Planning Commission Communication

Department: Community Development CASE #PR-23-006 Applicant/Property Owner: Jamie Augustine 8129 Fort Street Omaha, NE 68134	Ordinance No. _____ Resolution No. _____	Planning Commission: 11/14/2023
---	---	---------------------------------

Request: Public hearing on the request of Jamie Augustine to append a planned residential overlay onto property legally described as Lot 65, City Acres, City of Council Bluffs, Pottawattamie County, Iowa, and to adopt the associated development plan.

Location: 2637 Avenue ‘L’

FRONT ELEVATION

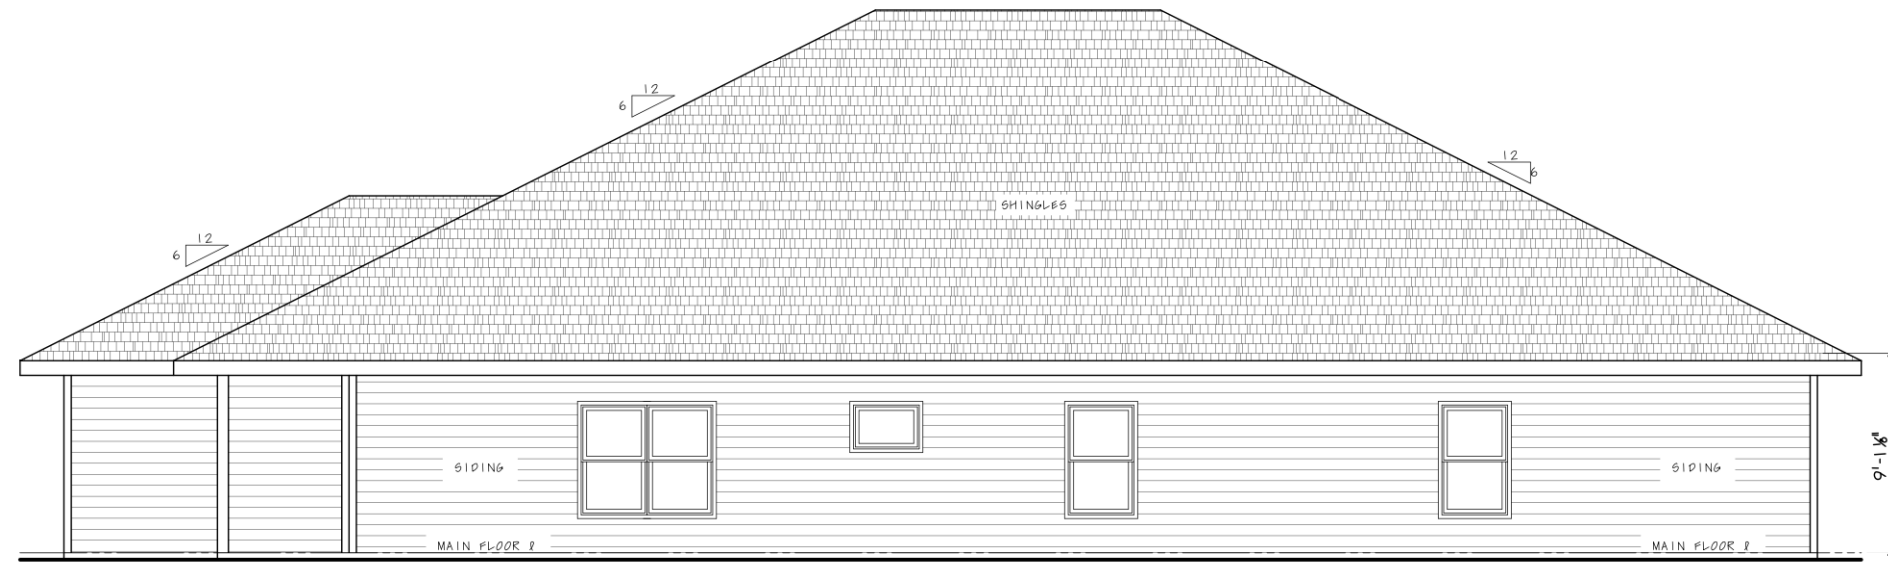
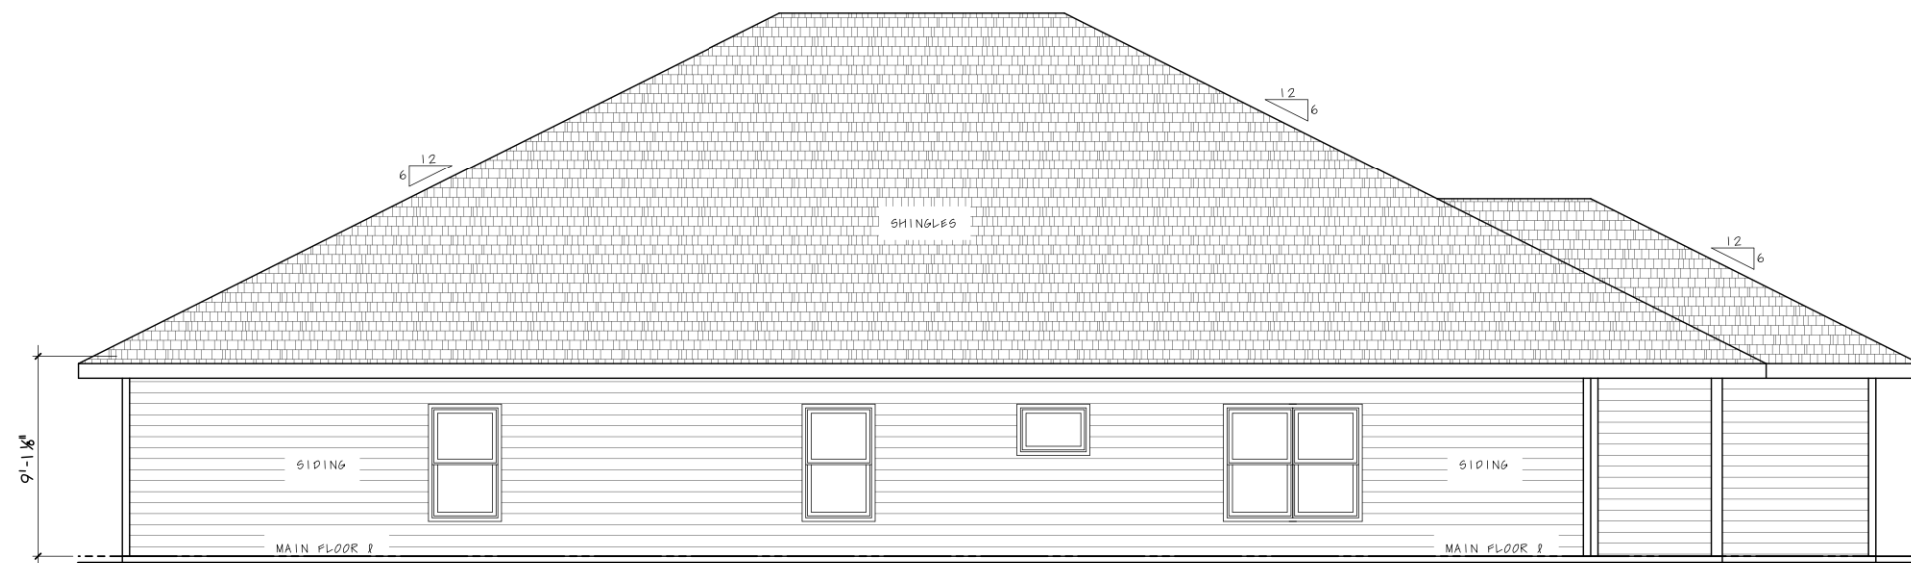
- c. The submitted building elevations (see Attachment 'C') show the proposed townhouse will measure approximately 25 feet in height, and thus will not exceed the maximum height allowed for principal structures in the R-1 District.

1. The submitted building elevations show the proposed townhouse will be one story tall with a slab foundation and front-loaded garages, and will be primarily constructed out of siding. To enhance the architectural design of the proposed townhouse and maintain the appearance of the surrounding area through the use of high quality, durable materials, the Community Development Department recommends that a minimum of 10% of the front façade be made of brick, stone or tile. Masonry materials shall be located primarily along the base of the building.
